REGULAR MEETING OF THE MIDLAND CITY PLANNING COMMISSION, TO TAKE PLACE ON TUESDAY, MAY 24, 2016, 7:00 P.M., COUNCIL CHAMBERS, CITY HALL, MIDLAND, MICHIGAN

Site Plan SP #349

STAFF REPORT TO THE PLANNING COMMISSION

SUBJECT: North Village Housing – Northwood University

SITE PLAN
 SCALE: 1" = 40'

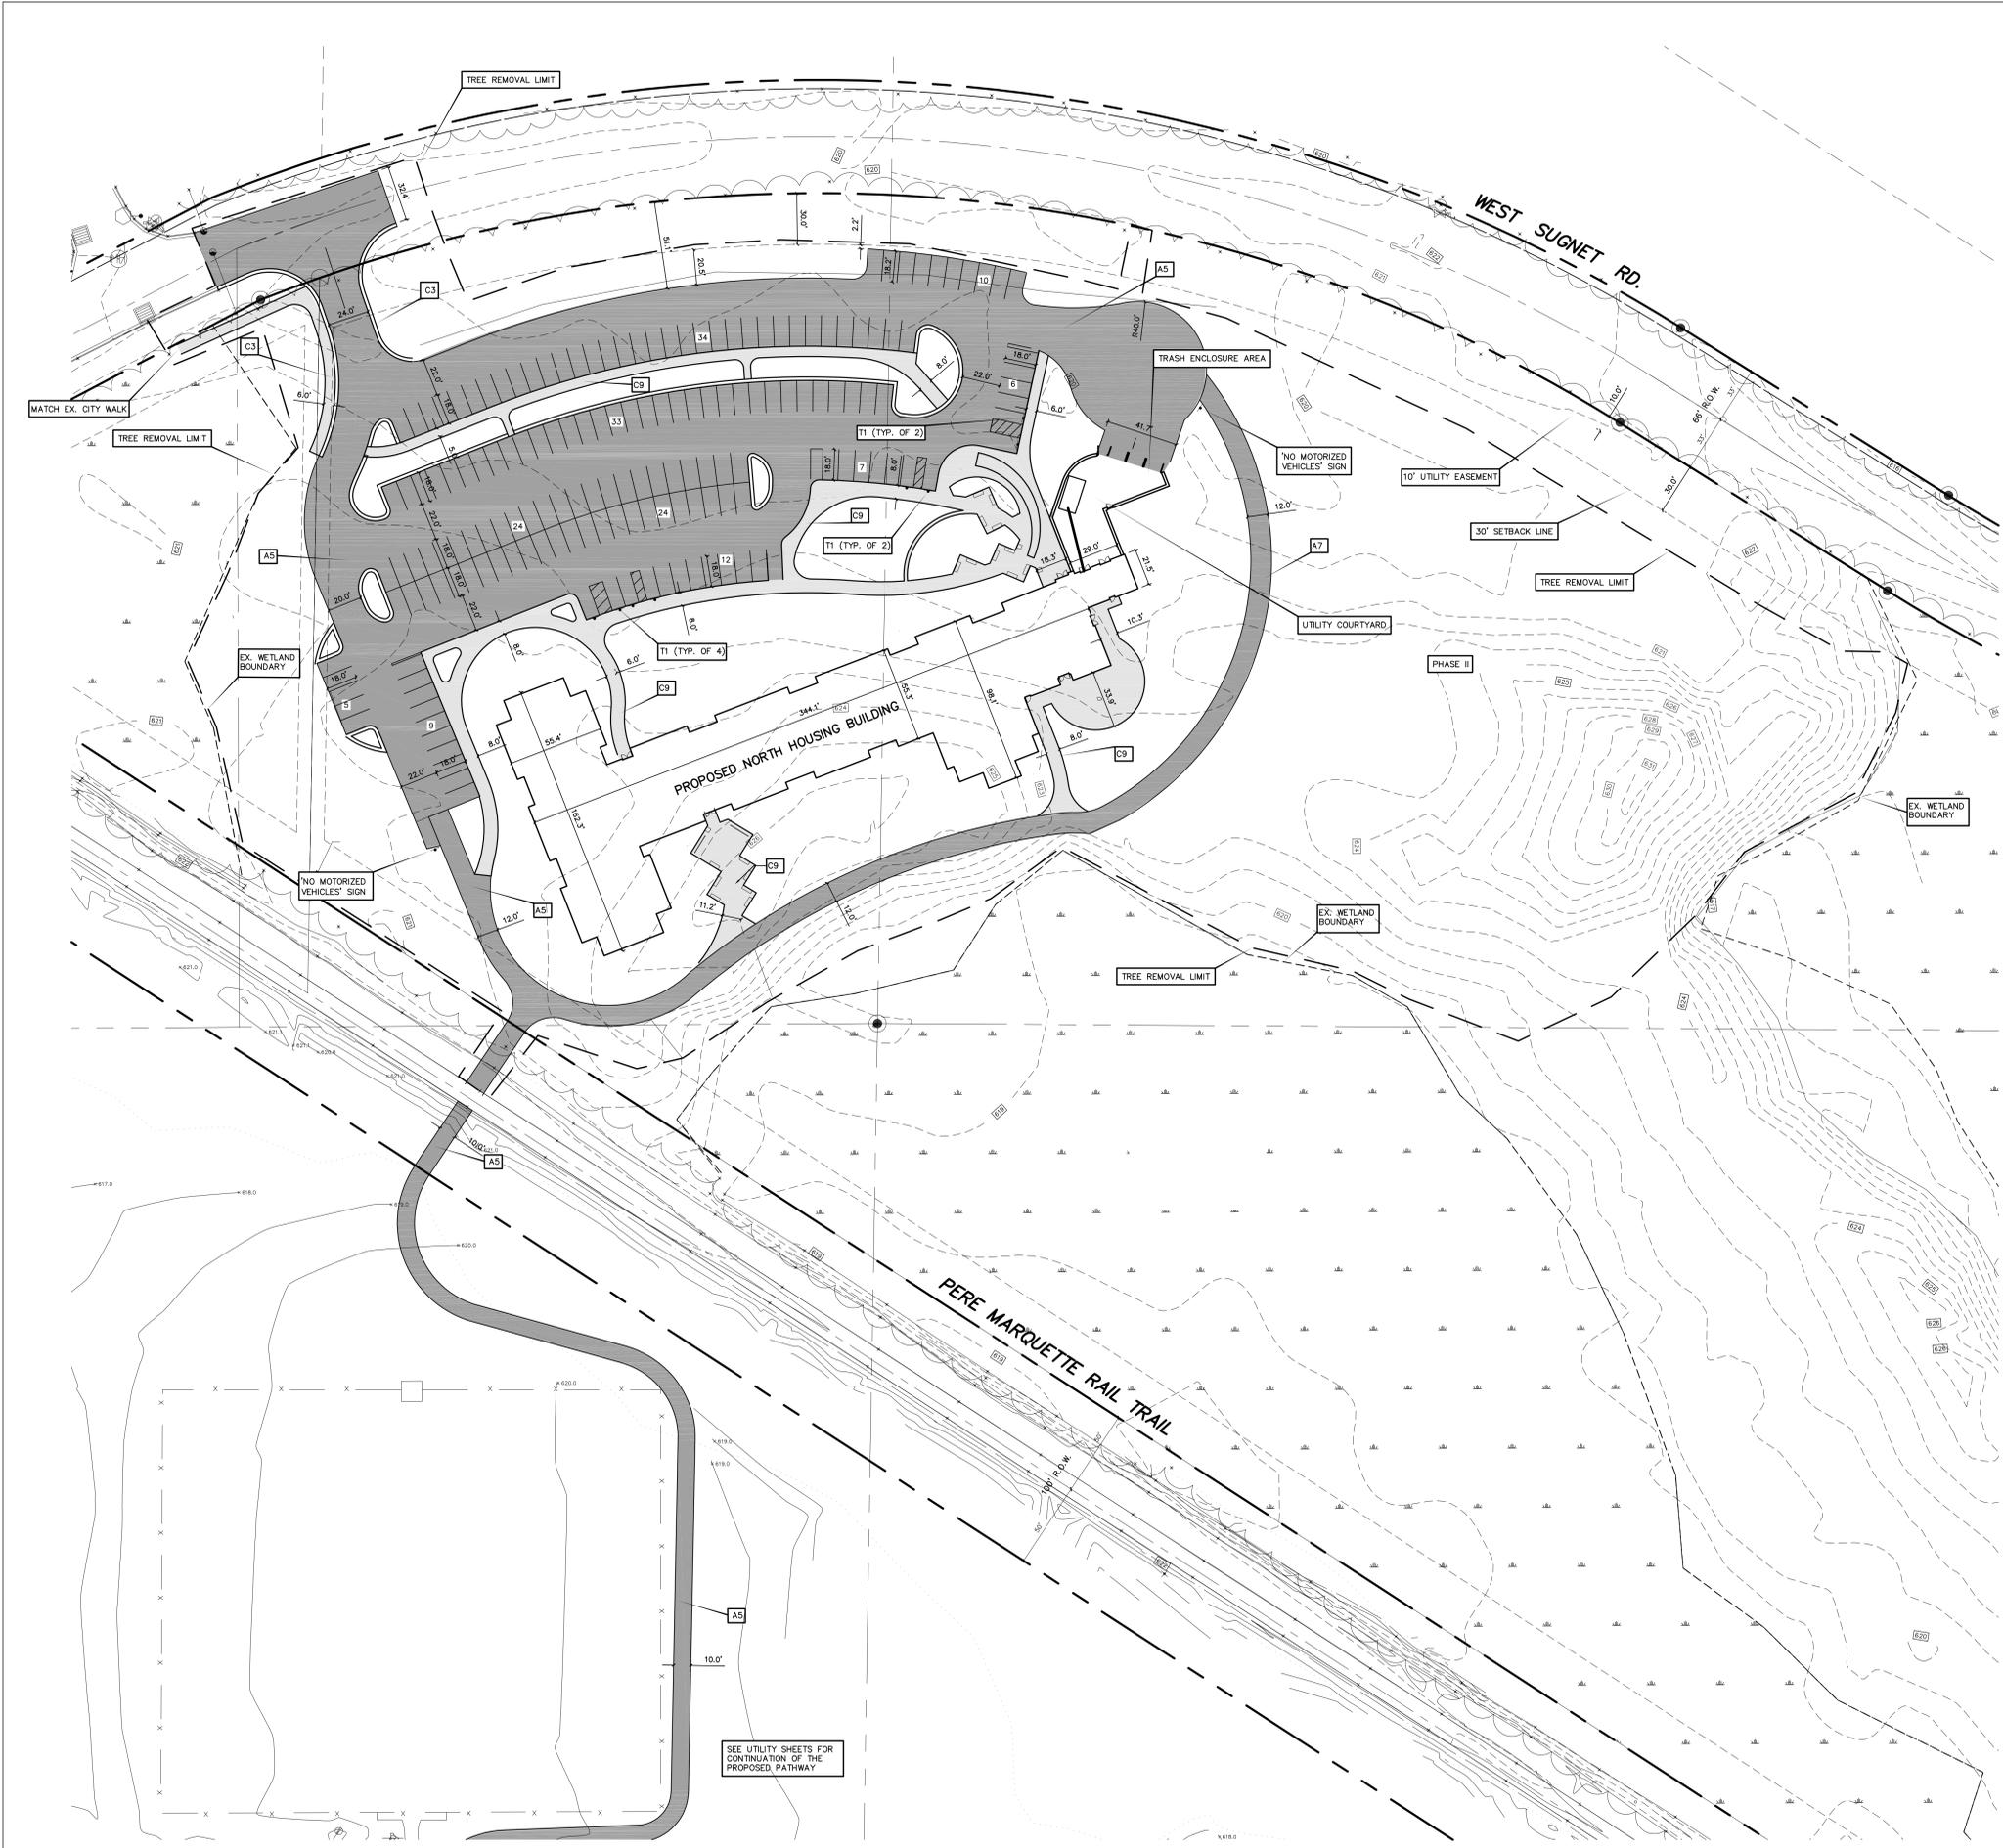
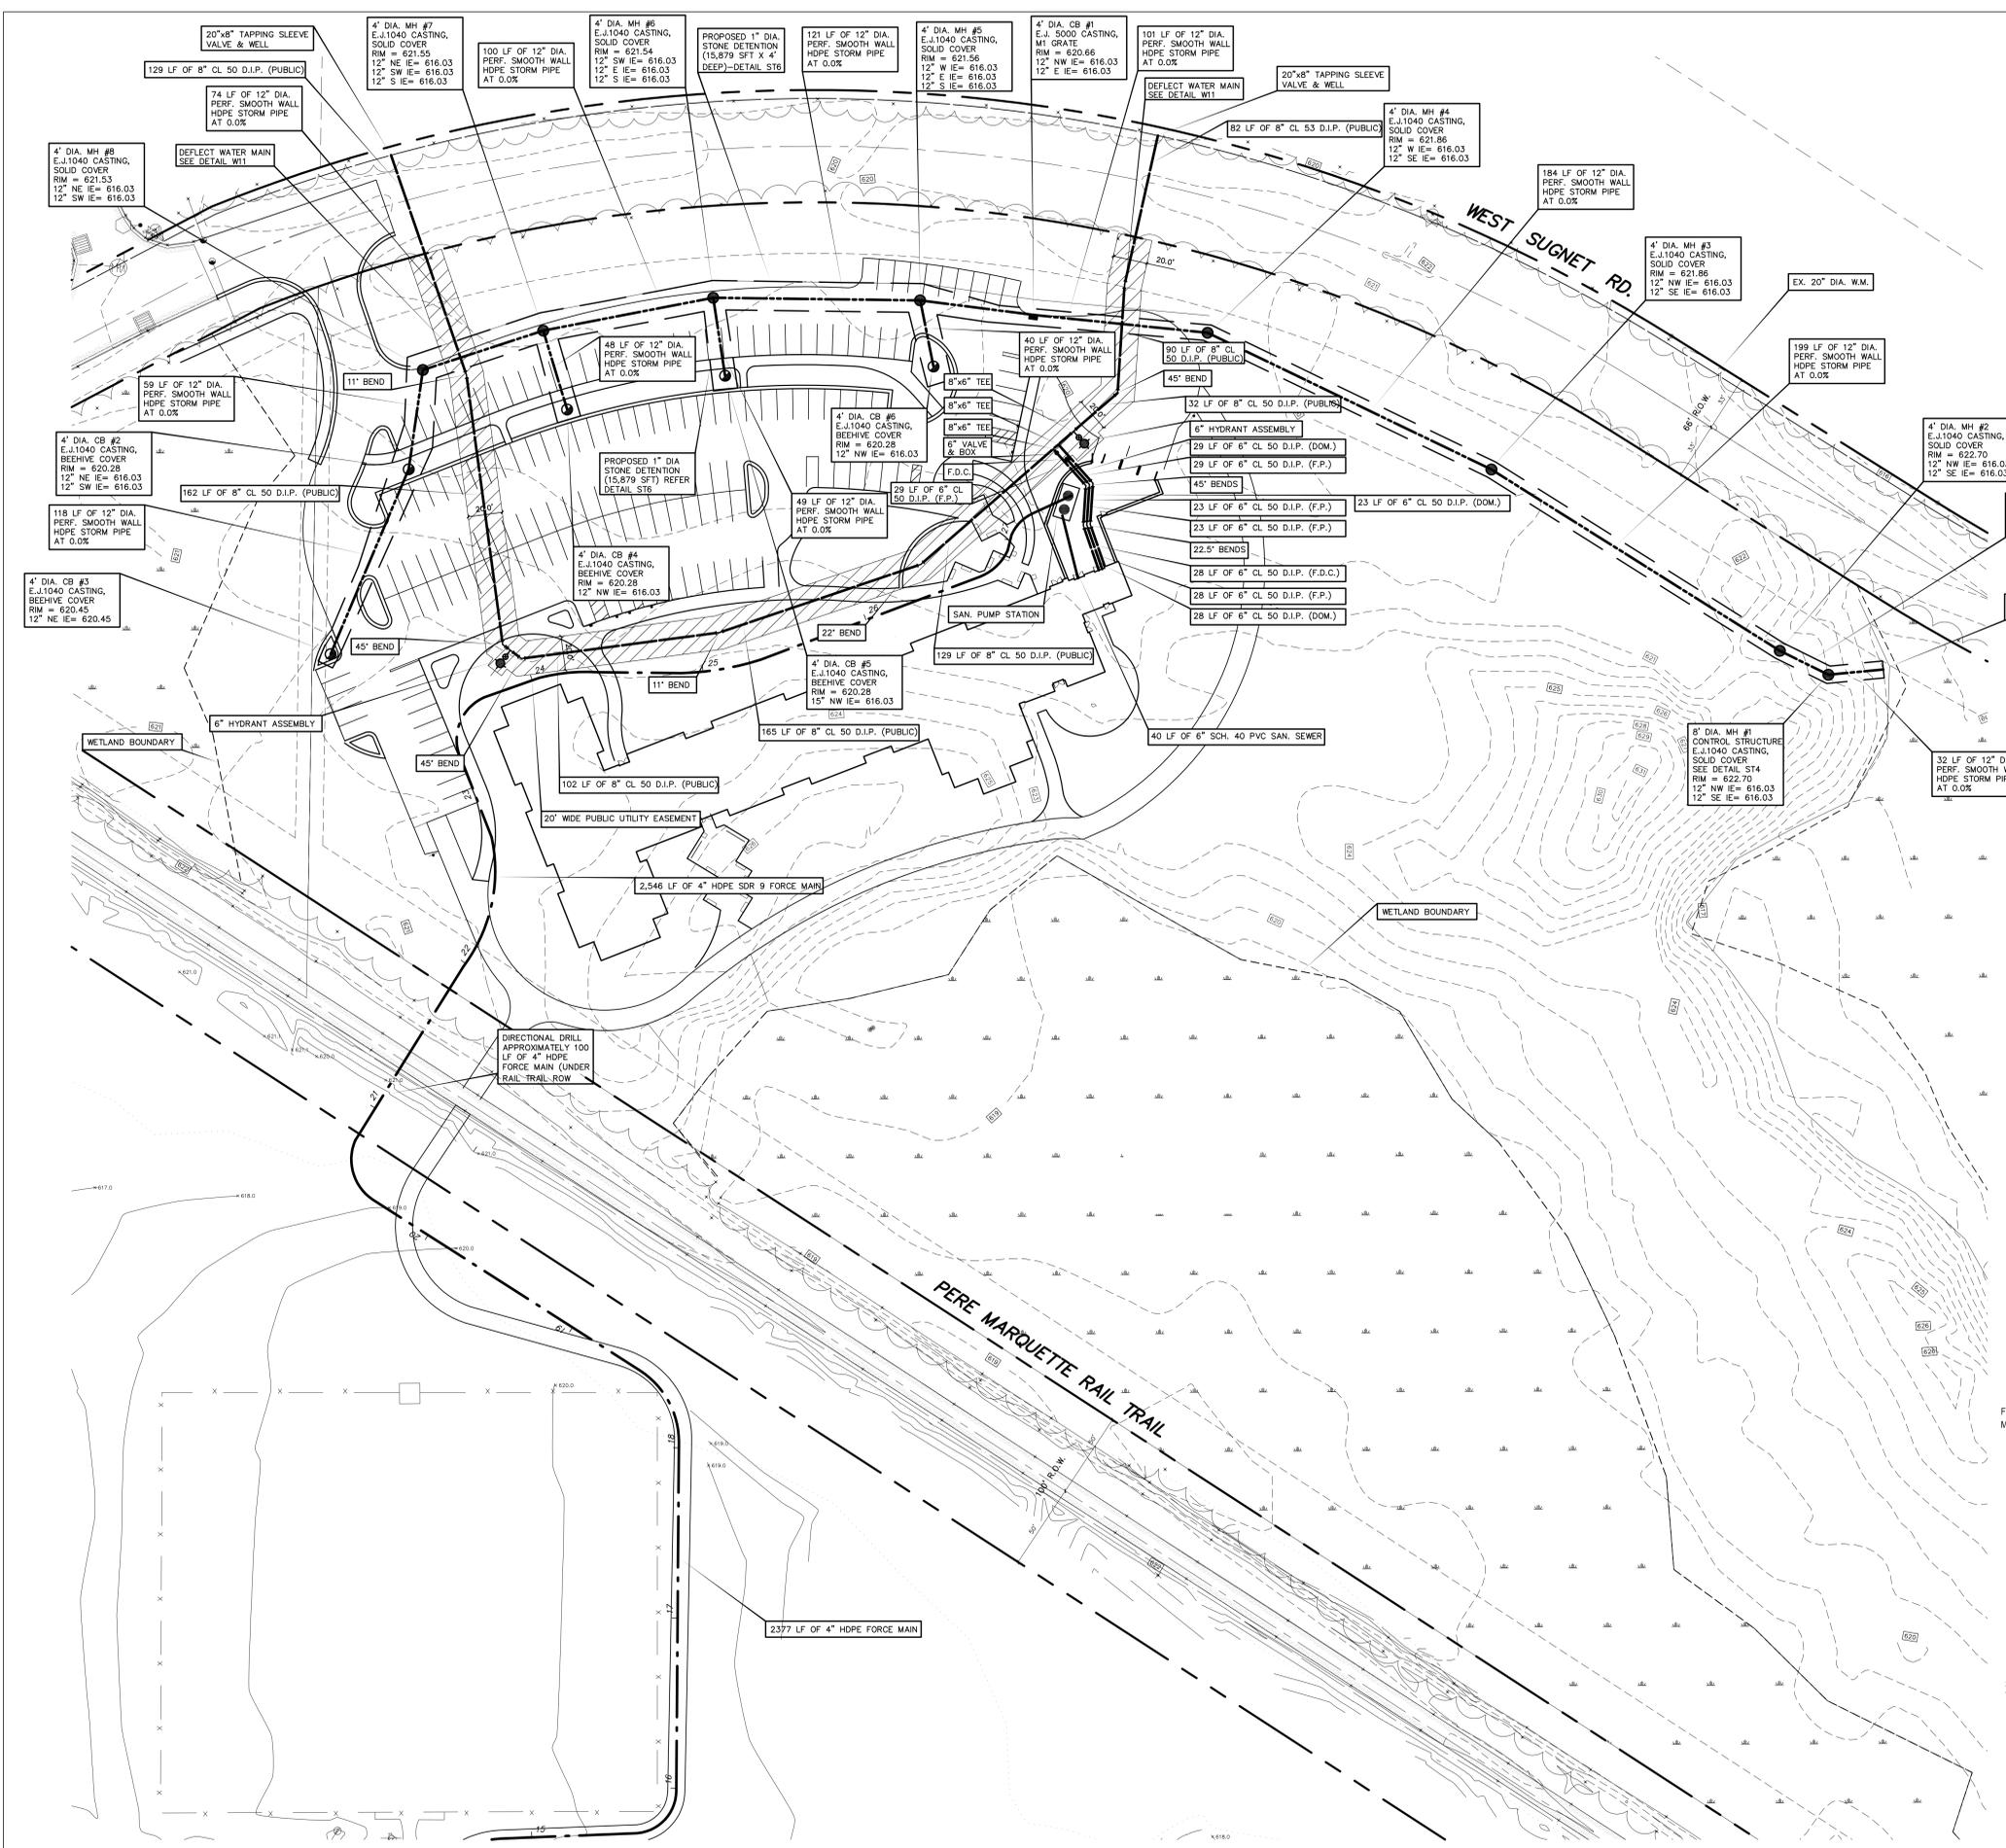
The proposed student housing facility design is seen as harmonious and efficiently organized on the site in relation to the abutting road network, the Pere Marquette Rail-Trail, and the existing Northwood University campus while avoiding the various wetlands that are within the property. The site design minimizes the removal of existing trees, a staple design of the heavily wooded Northwood University campus, while providing appropriate new landscaping elements. The proposal includes various non-motorized pathways that circulate throughout the site facilitating pedestrian and bicycling access for students. The site proposal includes a single vehicle access to West Sugnet Road.

Adequate vehicular site access is proposed utilizing a new access drive from West Sugnet Road. The proposal includes a sidewalk connection to the future West Sugnet Road sidewalk (to be installed this summer) as well as a non-motorized pathway connection to the Pere Marquette Rail-Trail and the existing Northwood University campus.

The parking proposed for the new development is compliant with Article 5.00 of the Zoning Ordinance.

STORM WATER MGMT.

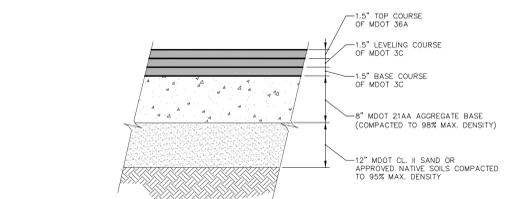
The City Engineering Department has reviewed the proposal and indicated that the calculations presented are sufficient to meet the City's stormwater management ordinance. The final stormwater permit must still be signed off by the City Engineering Department.
